W3F1-95-0136

Subject: Waterford 3 SES
Docket No. 50-382
License No. NPF-38
Modification to Primary Access Point

Modification to Primary Access Point

| DEPT. DRAFTING | DR. <i>[Signature]</i> | | SK-B-C-0157 |

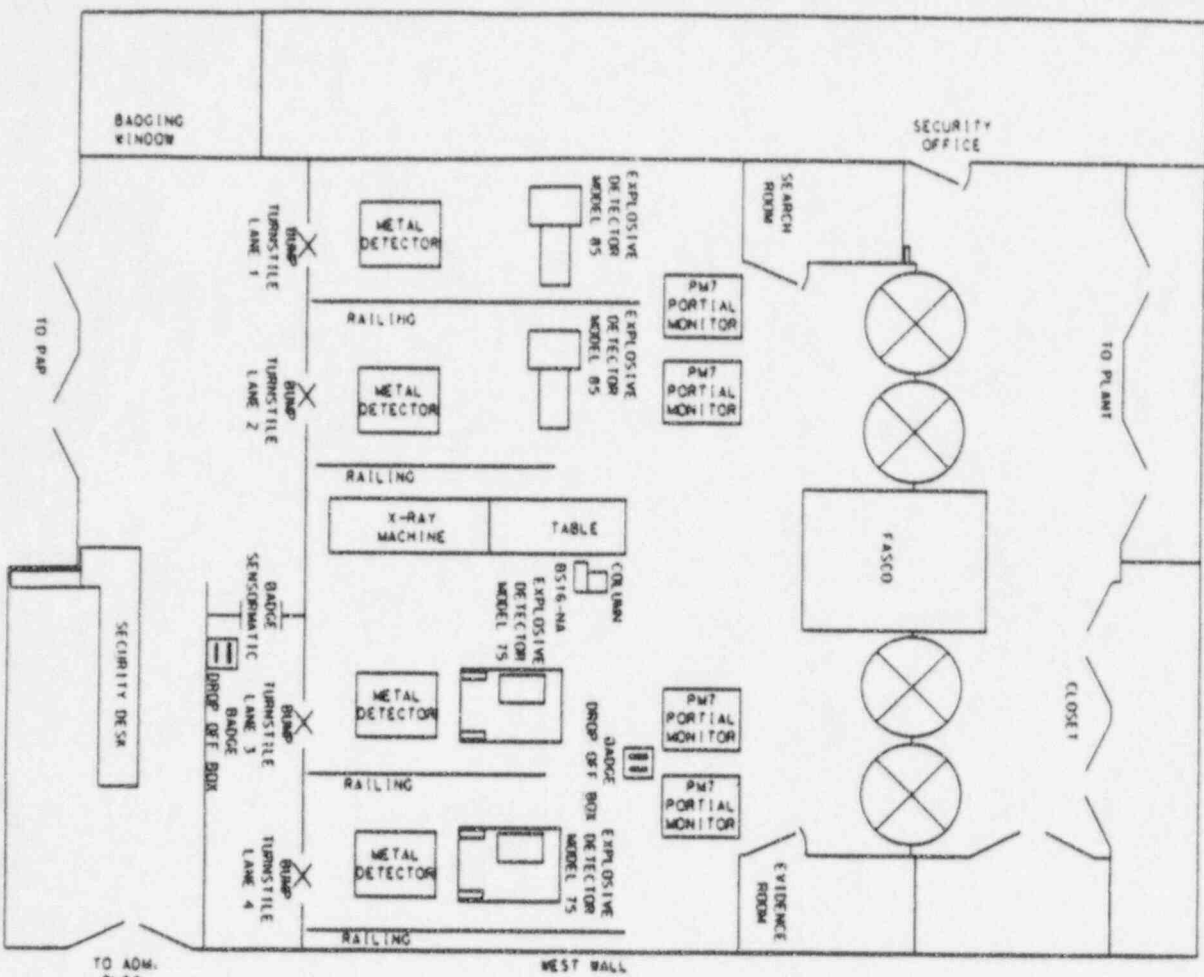
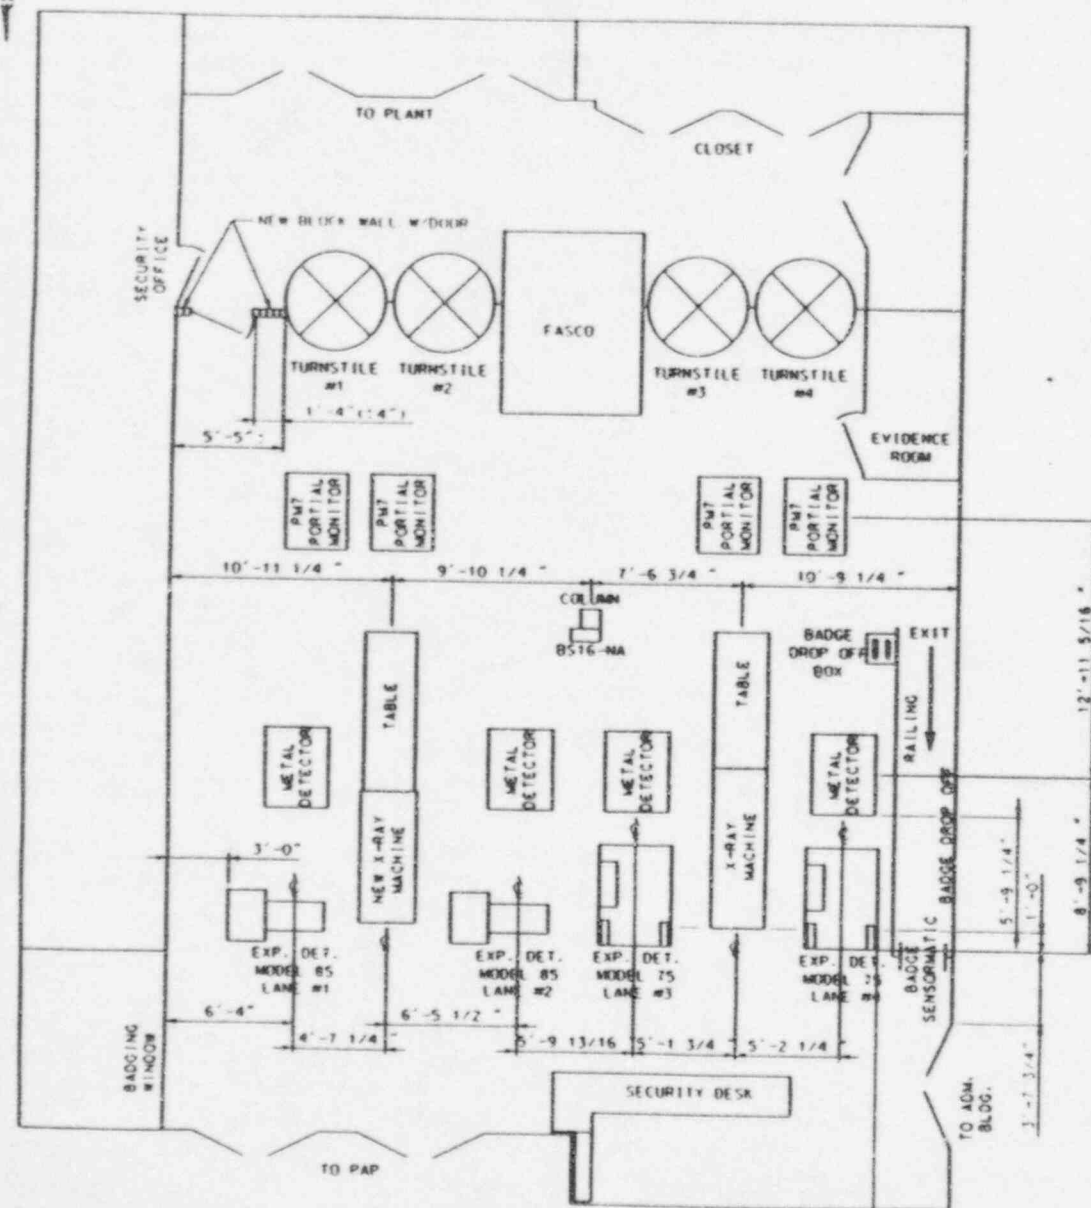
This Temporary Alteration will revise the layout of the PAP (See sketch SK-B-C-0157) to help expedite personnel and package monitoring by accomplishing the following:

- 1) Remove all bump turnstile stands.
- 2) Remove all rails except exit rail.
- 3) Swap metal detectors and explosive detectors.
- 4) Add new Hi-Scan 6040-A X-Ray machine between lanes 1 and 2.
- 5) Relocate existing X-Ray machine and mirror between lanes 3 and 4.
- 6) Relocate Sensormatic equipment to front of exit lane.
- 7) Install new security hollow metal door (DQ12) with lockset in South masonry block wall adjacent to gate turnstile 1.
